FINAL
**Environmental Impact Statement
United States Postal Service**

**Next Generation Delivery Vehicle
Acquisitions**

Title: Final Environmental Impact Statement for Purchase of Next Generation Delivery Vehicles

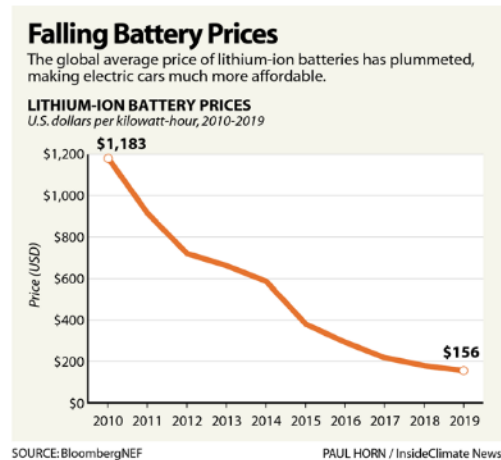
The claim that “BEV NGDV on routes that exceed 70 miles might not have sufficient power to complete the route” disregards advances in battery technology. COTS BEV vehicles today have a much larger range than assumed. For example, it is reported that the Mustang Mach-e is estimated to have a range of 211 to 300 miles for the Sport Utility Vehicle (SUV) (not counting the weight of packages in a delivery van version) and the Ford Transit Passenger Van electric vehicle is estimated for a range of 140 to 170 miles. This higher range is likely to be more compatible for the delivery routes that have been ruled out due to route length. Consideration of ranges more accurate with the current trends in BEV technology would both allow the decision maker a fair comparison among alternatives and consider deployment in areas currently ruled out based on the BEV NGDV range constraints. In addition, industry standards have batteries that would be sized more appropriately for the “low average delivery route mileage” that would reduce the overall cost of procurement and allow for an increase in the percentage of BEVs. For example, the inclusion of two or more options of battery range in the specifications (one less than 70 miles) could allow for meeting the majority of routes with a shorter range and less expensive battery option and for meeting the range needs of areas with longer routes with an extended range battery option. EPA recommends that the assumptions on the COTS BEV alternatives be updated to reflect a more accurate depiction of the current available technology² that meets the Postal Service’s vehicle replacement needs.

- EPA recommends that the Postal Service consider a diversified procurement and deployment strategy to accommodate both BEVs that may have a shorter range and be more cost-effective and BEVs that may have longer battery range(s) to address longer routes.

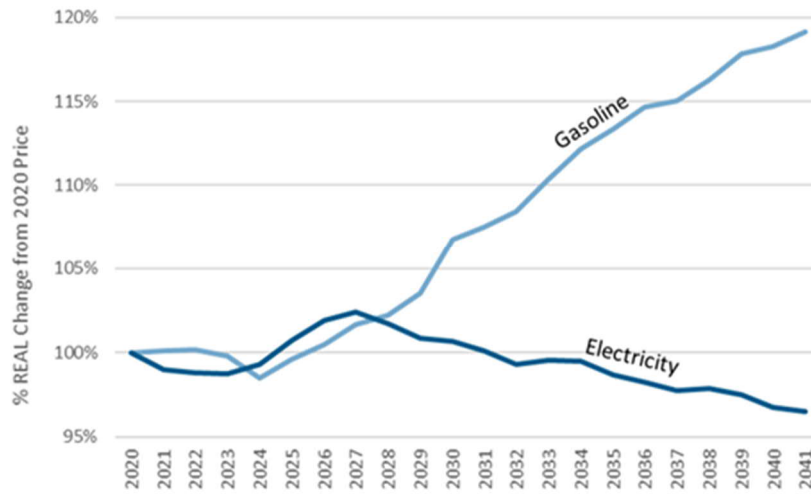
8	<p>The draft EIS sets several parameters for BEV vehicles that needlessly raise costs or overly constrain the potential deployment of BEV. The draft EIS states:</p> <p><i>"Operational limitations and certain Postal Service delivery environments would limit the use of electric-only vehicles. These limitations include a lack of available infrastructure, and at least 12,500 delivery routes where route length, environmental conditions, or facility constraints make electric vehicles unfeasible or impractical."</i></p>
	<p>As noted in response to Comment 3, the Postal Service has invested an estimated 450,000 manhours to complete comprehensive testing protocols on NGDV prototype vehicles, including both BEV and ICE. Protocols included Efficiency Testing, Durability Testing, Simulated Testing, Post Office Field Testing, Carrier Efficiency Testing, Winter Testing, and Fuel Economy Testing. Based on these tests and known route characteristics, the BEV NGDV battery is specified to support a daily 70-mile route at the end of its ten-year battery life. As stated in the FEIS, approximately 12,500 delivery routes cover distances that will exceed the designed battery capacity.</p> <p>Additionally, with respect to infrastructure, the Postal Service estimates, based on its assessment of the age and state of its infrastructure, that Postal Service facilities with more than four to five BEV NGDV will likely require additional power and electrical upgrades (e.g., circuit breaker panel, transformer and utility upgrades) to support the electrical demand, which will constrain, at least initially, BEV deployment in large carrier offices with a significant number of routes.</p> <p>Thus, the parameters set in the EIS are the result of this extensive analysis and designed to ensure that the Postal Service can reliably deliver the nation’s mail in multiple and varied operating environments. The Postal Service therefore disagrees that the BEV parameters “needlessly raise costs” or “overly constrain the potential deployment of BEV.”</p> <p>Please note that the approximate 12,500 delivery routes that are not suitable for BEV NGDV based on route length equate to approximately 5% of current routes. The Postal Service recognizes that advances in battery technology may occur over the next several years and if the range concerns can be overcome, the Postal Service may be able to consider these routes to be served by BEV NGDV.</p>

#	SECTION 1: ENVIRONMENTAL PROTECTION AGENCY (EPA) COMMENTS Comment (first row) USPS RESPONSE (in subsequent row)
	<p>The EIS has been revised to clarify that the 12,500 number refers solely to routes unsuitable for BEVs on account of route length, not environmental factors or other operational constraints.</p>
9	<p>As this is a 10-year plan, it should not be based on current availability of charging infrastructure. Charging infrastructure will be built out substantially and quickly in the next few years.</p>
	<p>The Postal Service BEVs will need to be charged at Postal Service facilities in order to account for the mail delivery cycle. Therefore, the TCO for BEV NGDV accounts for the cost of Postal Service-built charging infrastructure and not the potential availability of third-party charging stations. The Postal Service also notes that NGDV will not be configured for Level 3 fast charging, which is another reason why BEV NGDV will need to be charged at Postal Service facilities.</p>

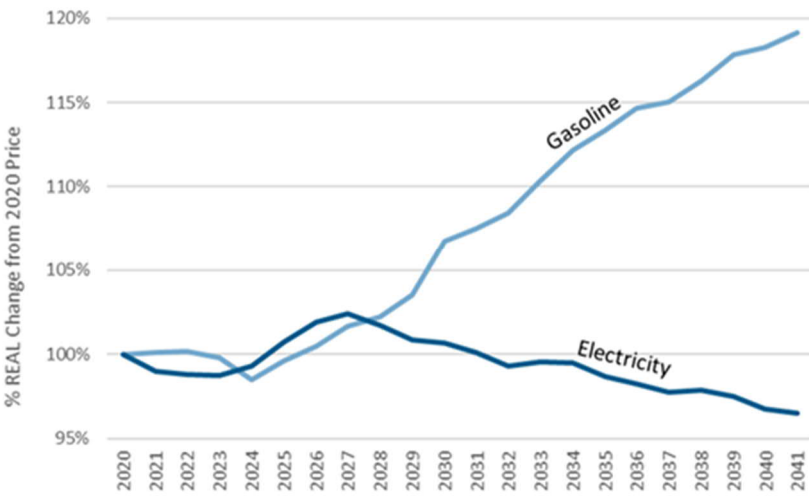
17	<p>EPA recommends that the Postal Service update the economic analysis and draft EIS to incorporate the assumptions of falling costs of battery technology as recommended by academics and industry experts. A range of forecasts of battery prices should be used, based on forecasts from government and private sector institutions. All forecasts should be clearly presented and cost implications for the TOC disclosed.</p>
	<p>See response to Comment 16 for why the Postal Service declines to credit cost forecasts over competitively-negotiated prices in the open market.</p>

#	<p>SECTION 1: ENVIRONMENTAL PROTECTION AGENCY (EPA) COMMENTS Comment (first row) USPS RESPONSE (in subsequent row)</p>
18	<p>Important data on the costs of components of ICE NGDV and BEV NGDV are not provided. The cost of gasoline, the cost of electricity, and the cost of maintenance are not provided in the economic analysis. It is well-documented that the costs of ownership, including maintenance and fuel costs, are considerably lower for BEVs. The lower costs include not only repair cost savings but also spending less time in the shop and more on the road.</p>
	<p>See response to Comment 13 as to why the Postal Service does not believe that NEPA requires the disclosure of commercially-sensitive information protected under other federal statutes, such as the Freedom of Information Act and Postal Reorganization Act. Also see response to Comment 13 for discussion of TCO components and methodology.</p> <p>Additionally, the Postal Service disagrees with the EPA’s opinion that “the costs of ownership, including maintenance and fuel costs, are considerably lower for BEVs.” Many commonly available and referenced COTS vehicle platforms use the Urban Dynamometer Driving Schedule (UDDS) Drive Cycle (Federal Test Procedure [FTP]-75) to estimate vehicle maintenance requirements and costs. However, the Postal Service has a unique slow speed, stop and start operating environment that is much more severe than the commonly-used UDDS drive cycle. The Postal Service’s curb-line delivery operations include hundreds of daily hard accelerations and decelerations for curbside delivery. This level of wear and maintenance is not experienced by light-duty vehicles operated on UDDS type driving cycles and has historically required the Postal Service to require engine and transmission replacements in fewer than 100,000 miles.</p> <p>For these reasons, Postal Service maintenance projections are based on actual historical LLV curb-line delivery vehicle maintenance costs, with vehicles driven to support Postal Service delivery operations. The Postal Service has developed maintenance cost ratios for each vehicle system based on Postal Service and industry subject matter expert consensus. The ratios for each vehicle were developed based on part costs and labor hours provided by the supplier. Panel members then reviewed and discussed supplier data to determine reasonableness of the data and gain agreement on the ratio of the NGDV relative to the Postal Service LLV delivery platform. This ratio represents the relative cost of each type of repair based on the LLV historical maintenance cost data. Both BEV and ICE maintenance requirements were calculated, and the systems analyzed for the anticipated 20-year useful life of the vehicles. Due to the anticipated extended life of the vehicles, powertrain requirements and BEV battery replacements were included in the maintenance cost calculations.</p> <p>Due to the significantly increased feature set (e.g., air conditioning and camera systems), both BEV NGDV and ICE NGDV vehicles had greater projected lifetime maintenance costs than the 30-year old baseline LLV, while ICE had higher projected maintenance costs than the BEV variant, which relative differences are incorporated into the TCO calculations.</p> <p>Additional detail has been added to the TCO explanation in Appendix C of the FEIS.</p>
